# NUCLEAR SAFETY EVALUATION FOR THE USAF MHU-83/E MUNITIONS HANDLING/LOADING LIFT TRUCK

TECHNICAL REPORT NO. AFWL-TR-68-149

The MHU-83/E Munitions Handling/Loading Lift Truck was evaluated against nuclear safety criteria. Results show that the MHU-83/E is well designed with respect to safety features and will adequately withstand intended loads.

Figure 5. Boom Chassis Interface

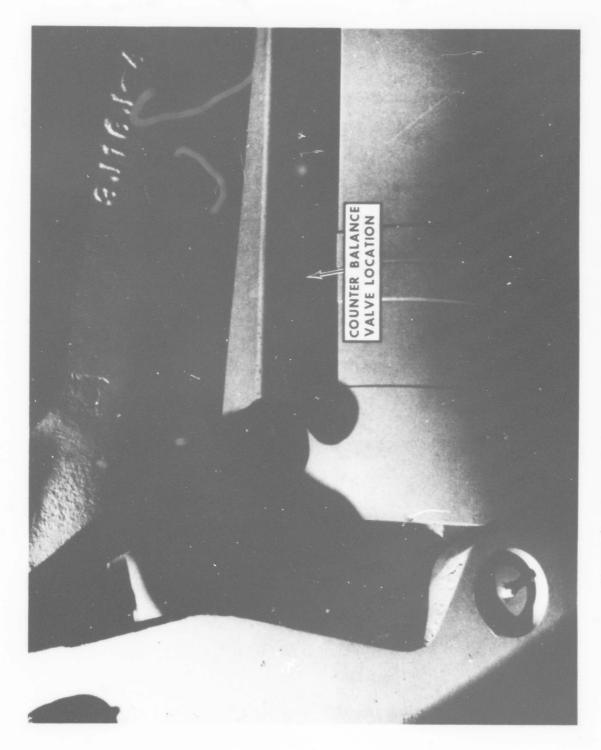
- h. To prevent abrasion of the flexible hydraulic lines near the interface between the chassis and boom (Figure 5), rubber grommets are being added to the chassis metal edge and the sheet metal on the boom will be rounded to eliminate the sharp edges. (Information provided by AFATL (ATZC) to WLDM per telecon 15 Nov 67).

Figure 15. Bomb Stand and Bomb Cradle

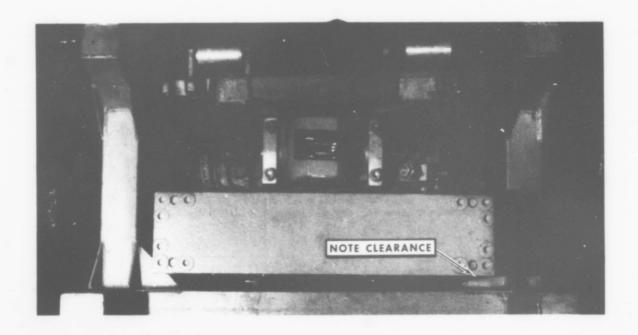
- a. Static overload tests were conducted on the lift truck with the fork lift adapter installed. The adapter withstood twice the full rated load without degradation or structural failure. (Technical Report No. AFSWC-TR-67-13.)
- b. The bomb stand presently being used is not of adequate size. As shown in Figures 14, 15, and 16 there is very little room for the manipulator head to move under the weapon and through the stand. This is far from an ideal condition and the stand should be modified. With the stand as currently designed it would not be hard to strike the weapon with the bomb cradle, or the stand itself, and knock the weapon off.

- a. The lifting forks are adequate from the standpoint of nuclear safety.
- b. The present bomb stand (Federal Stock No. 1730-624-1132) is not of sufficient height and width to be safely used in weapon loading with the MHU-83/E Bomb Lift Truck. A new stand should be designed for this purpose.

- The MHU-83/E Munitions Handling/Loading Lift Truck is well designed with respect to safety features and will adequately withstand intended loads.
- 2. The Bomb Stand (Federal Stock No. 1730-624-1132), although not supplied with the unit, is presently used for weapon loading. The clearance between the bomb cradle and the stand is considered to be marginal and the stand should not be used with the MHU-83/E.
- 3. A system for numbering the roller holes on the bomb cradle and forks should be added to facilitate loading and ensure proper roller placement.
